ADDENDUM NUMBER 5

October 23, 2024

PROJECT: Africatown Welcome Center
1959 Babridge Cutoff Road
Mobile, AL
MM Project # 502100719

ARCHITECT: Mott MacDonald

Storm Tank Module System on Stone Base, 12" Stone Cover
 Brentwood Industries, Inc.
 508 Sand Ridge Drive
 Revere, PA 15081
 Phone: (724) 632-0009
 Fax: (724) 632-0010
 www.storrtank.com
 info@storrtank.com

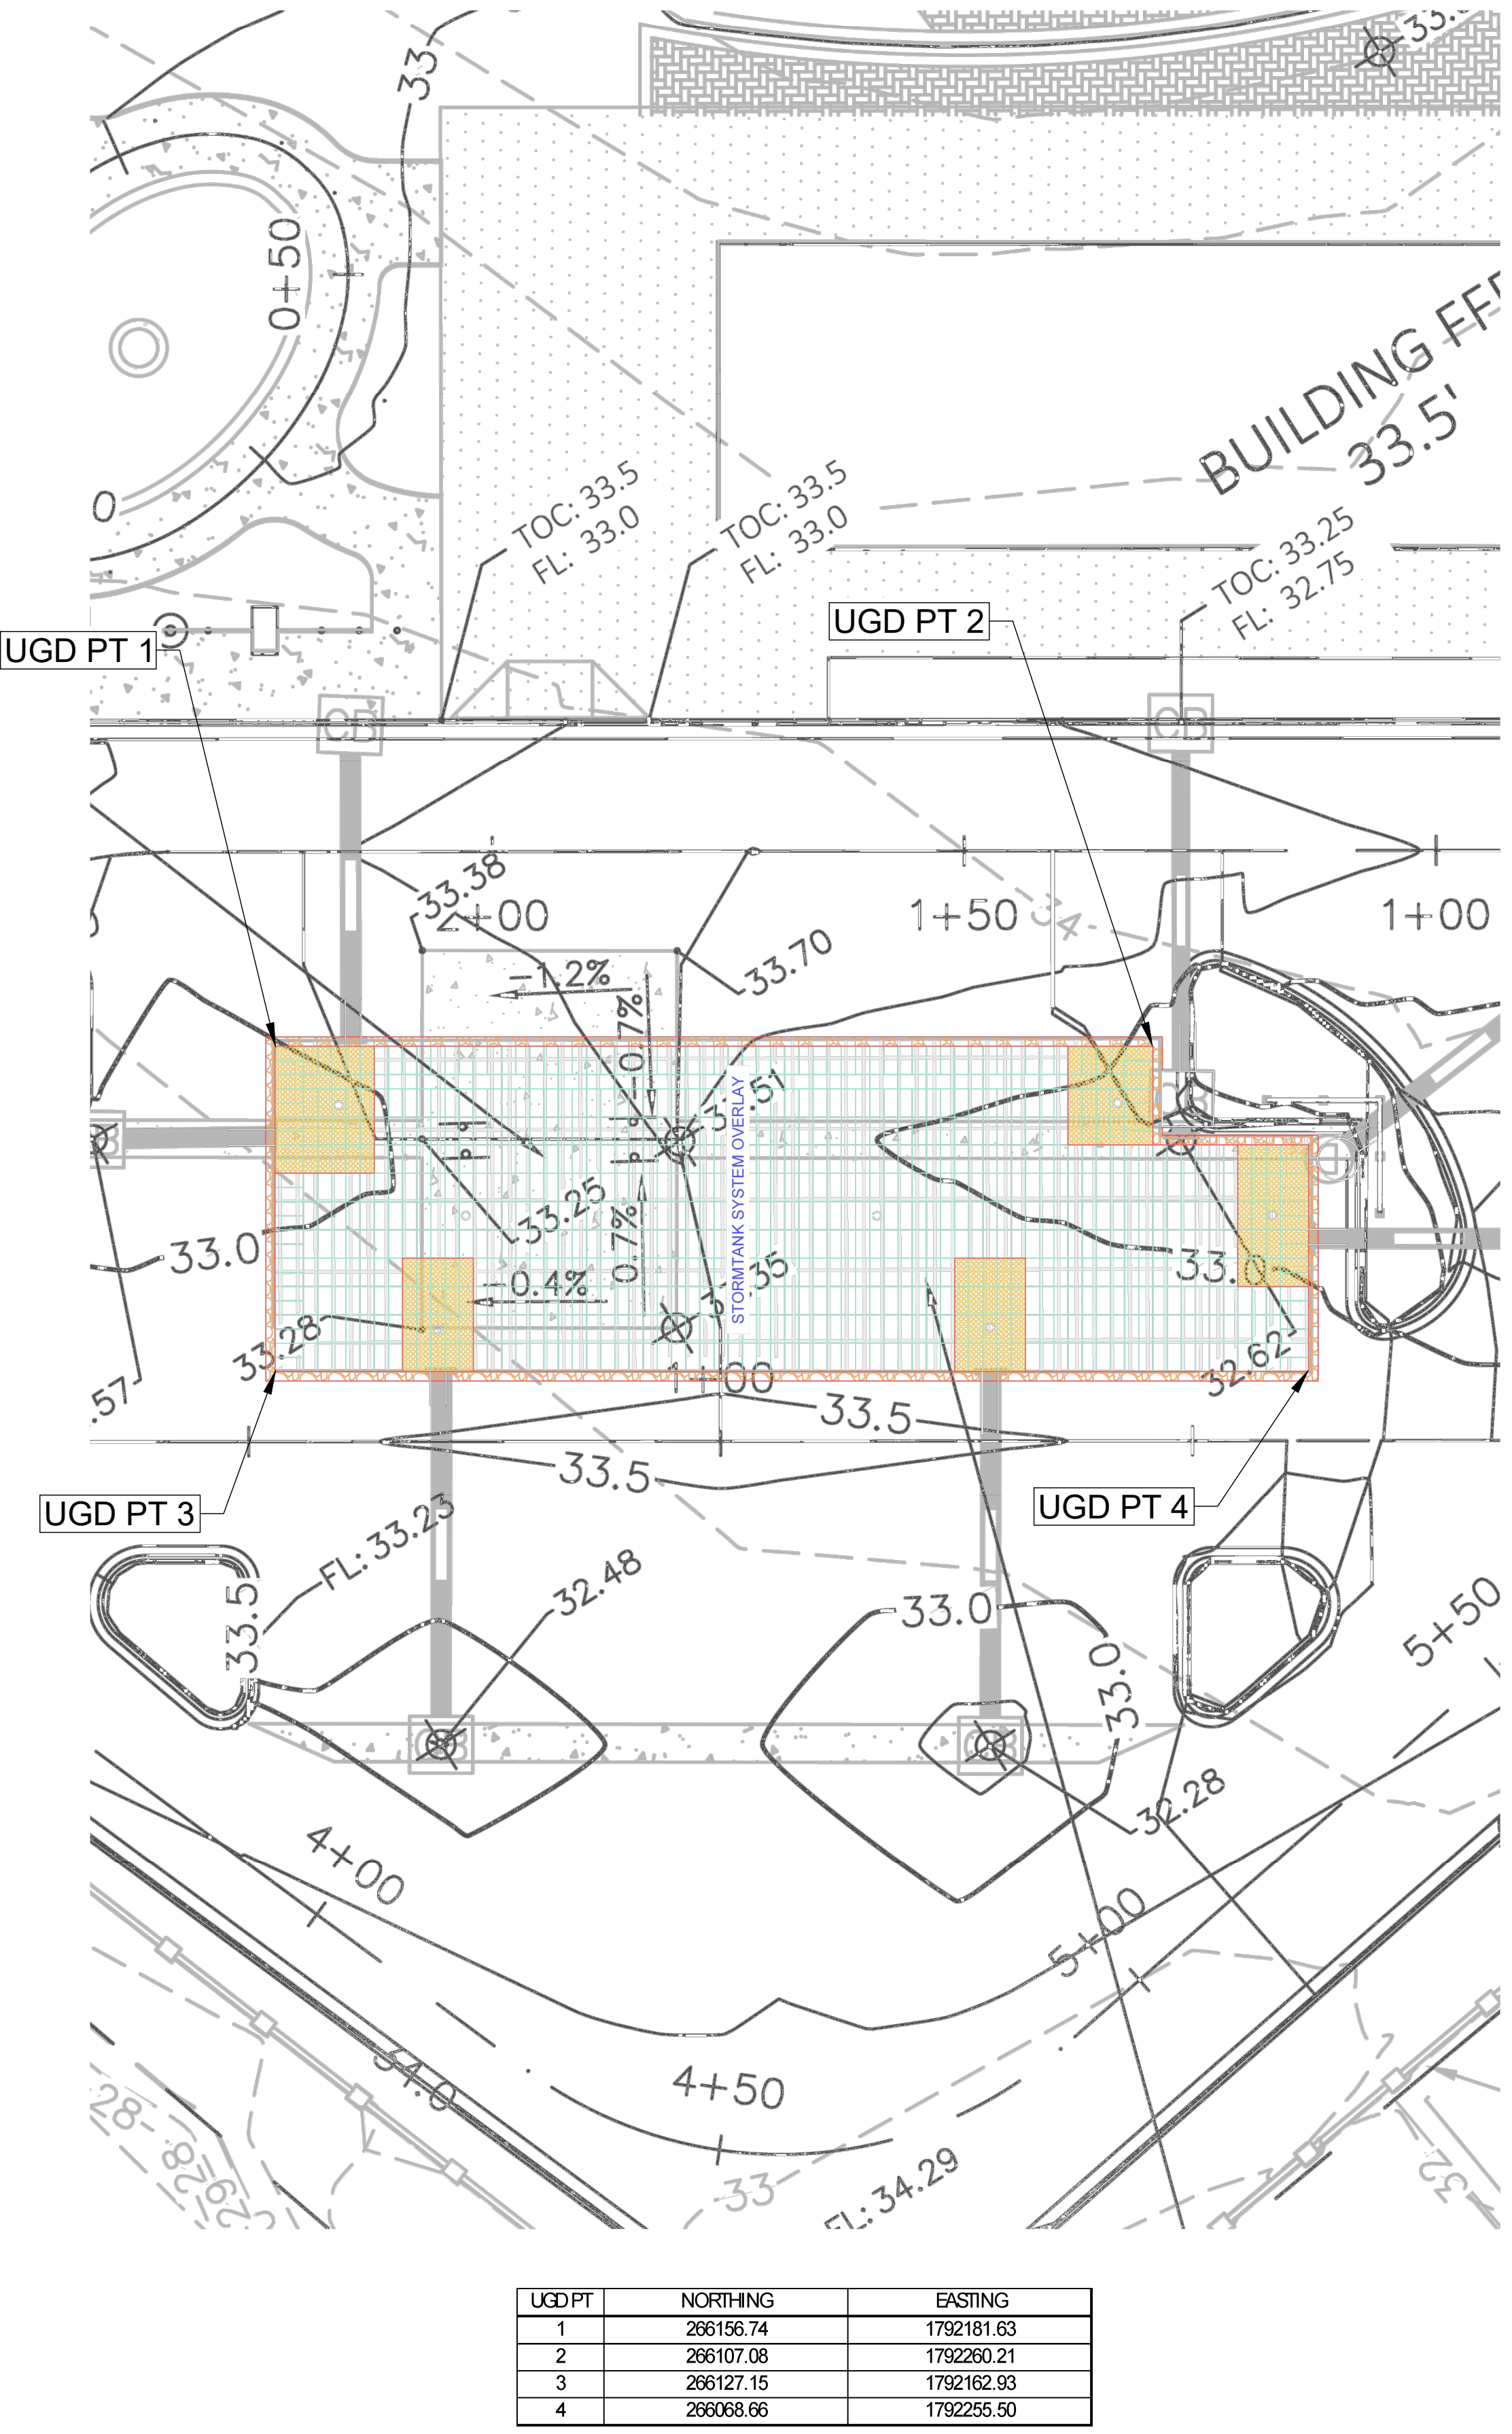
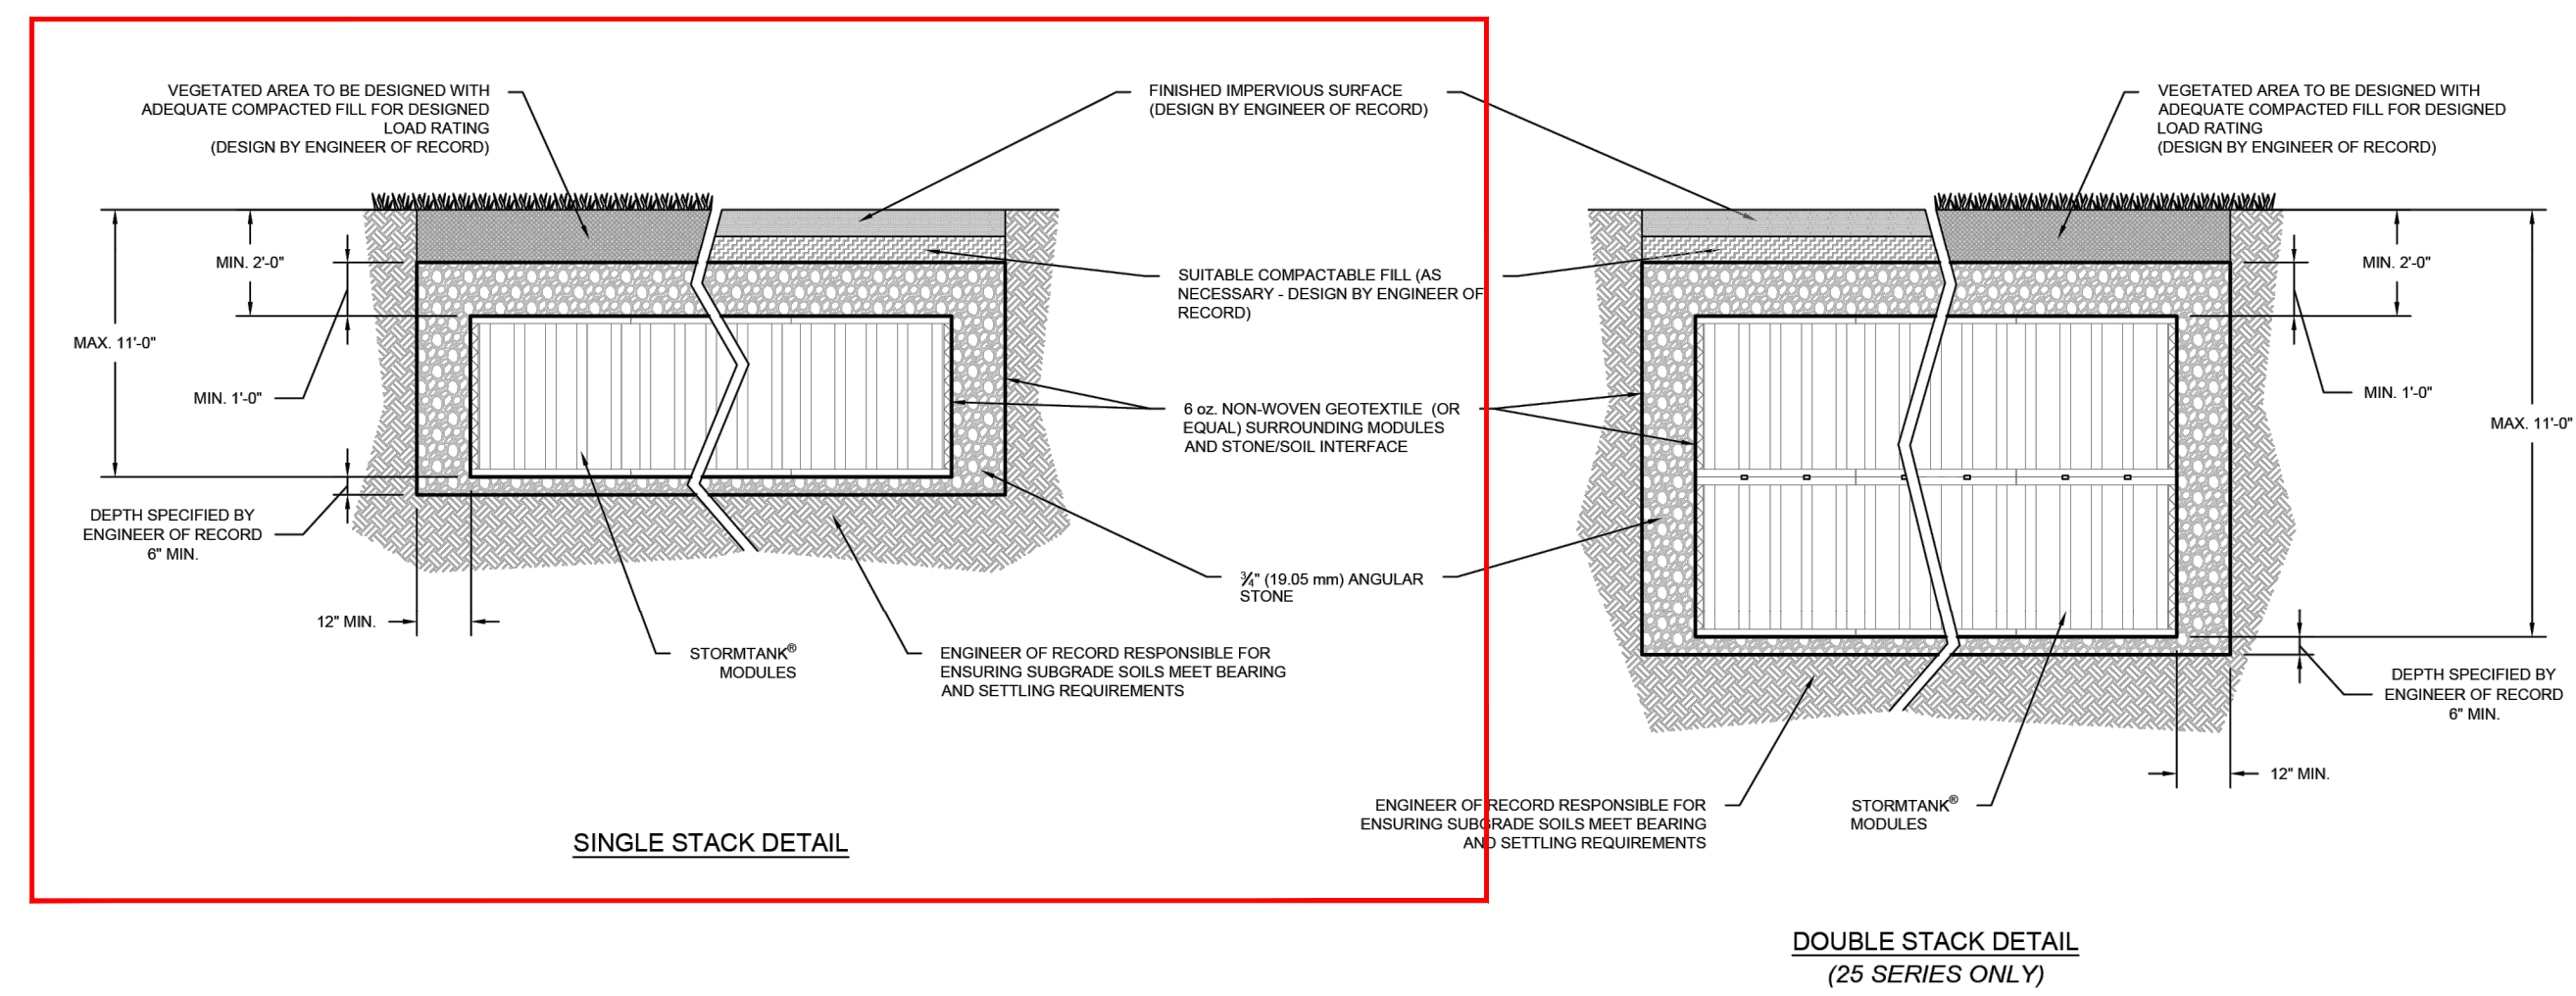
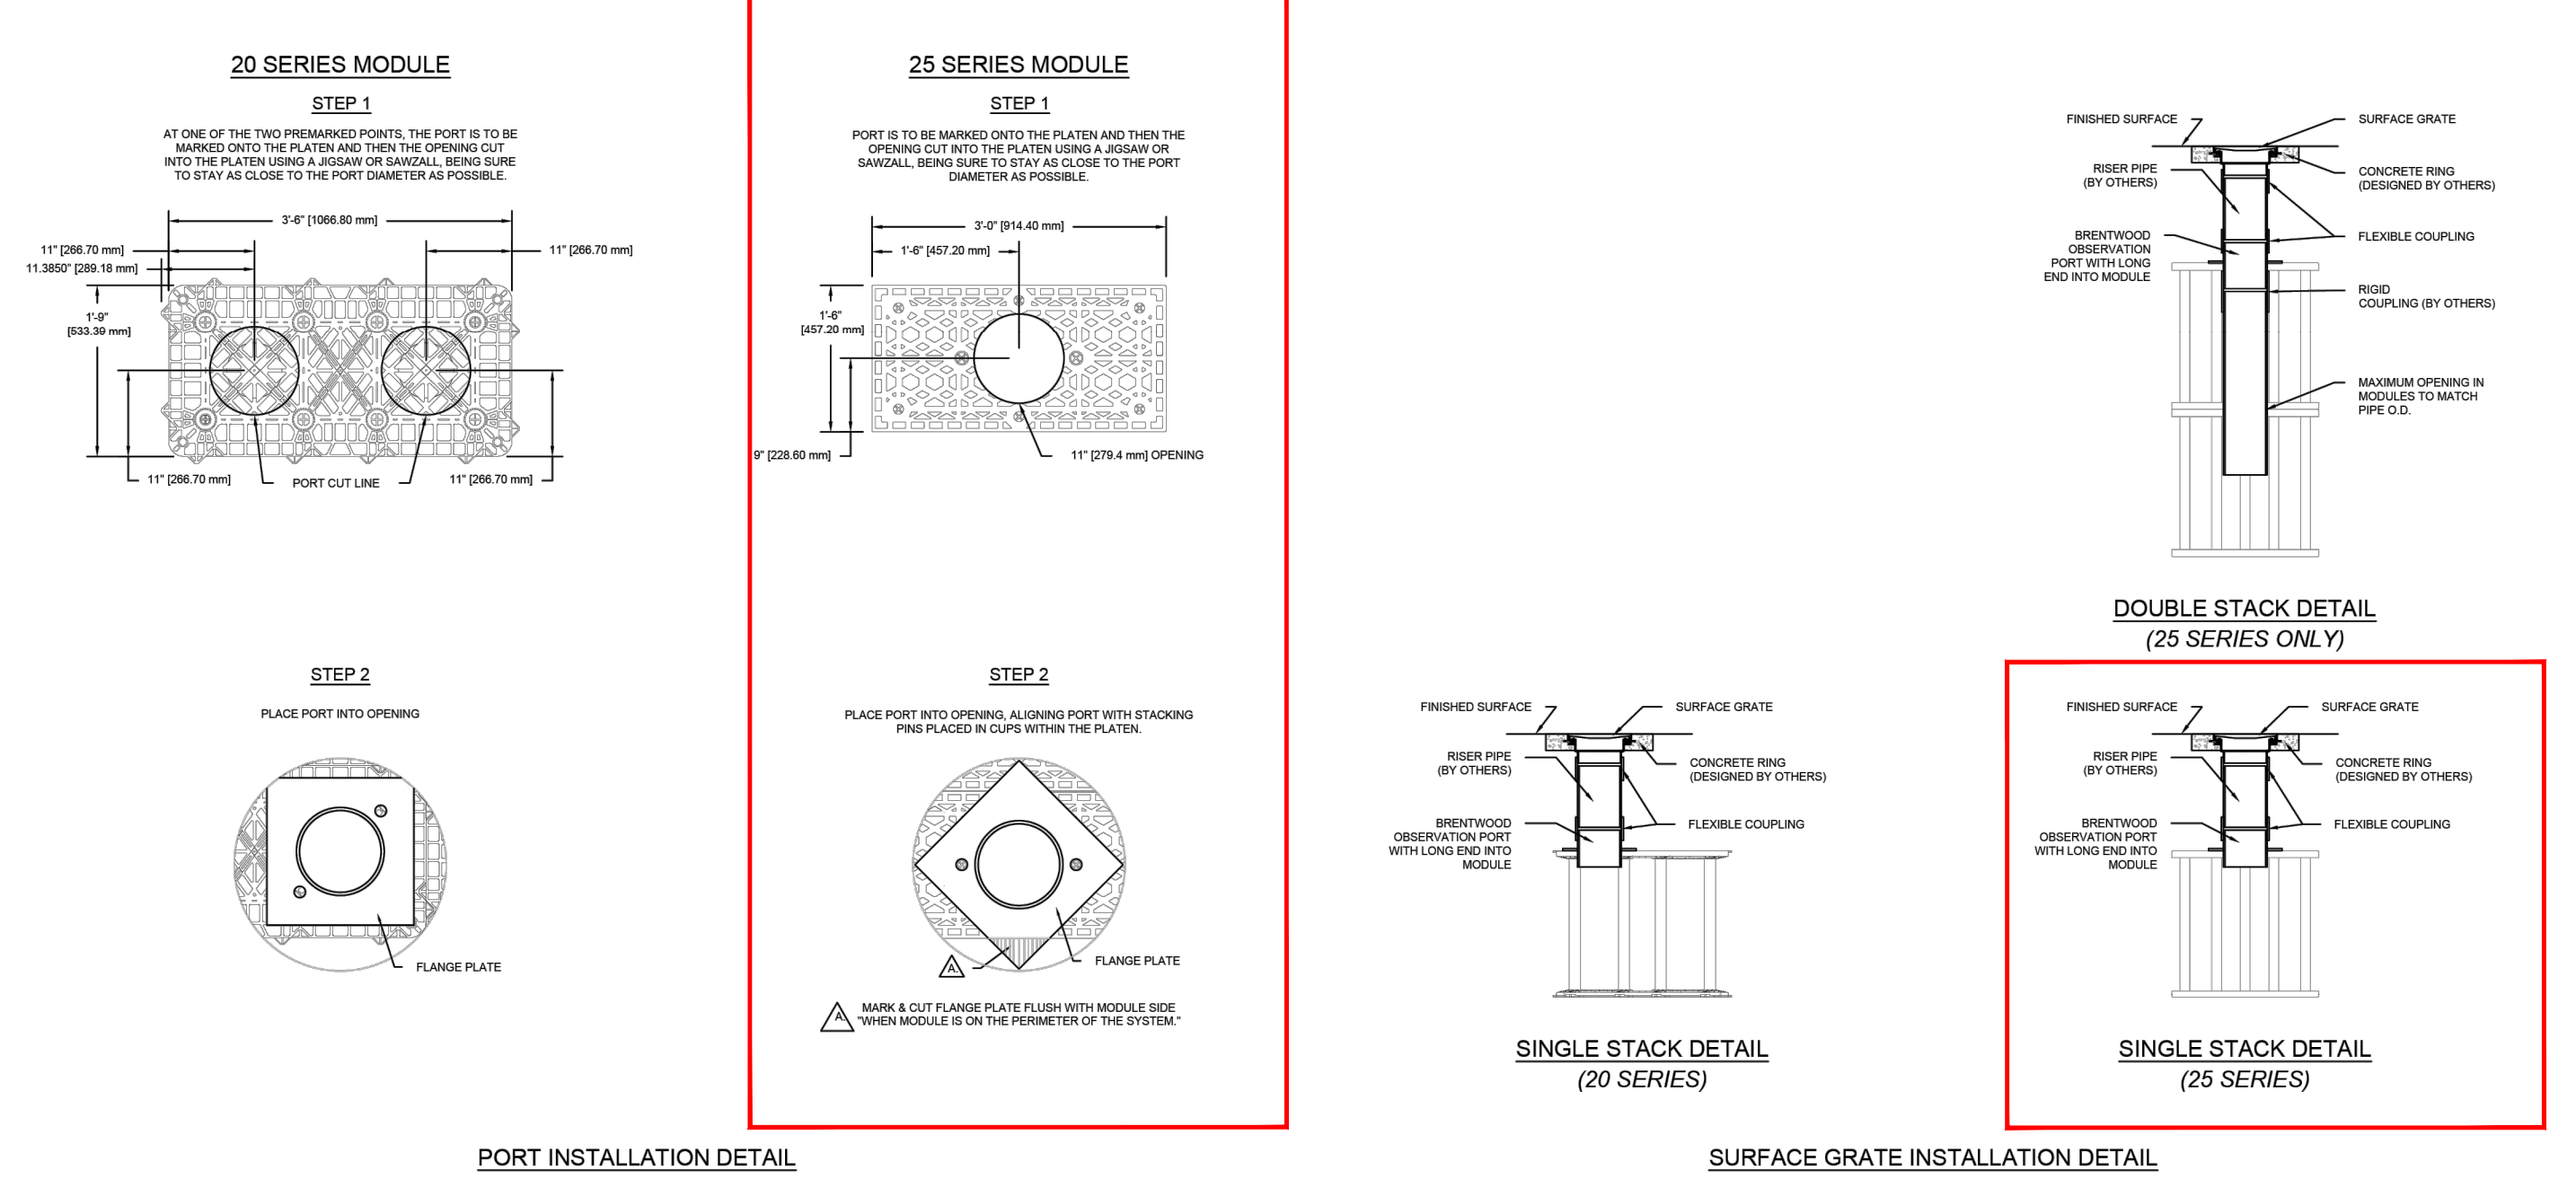
- a. Horizontals may be run continuous from door jamb to door jamb.
7. Please provide a detail sheet on the underground detention system.
 - a. See Updated Civil package (Attached).
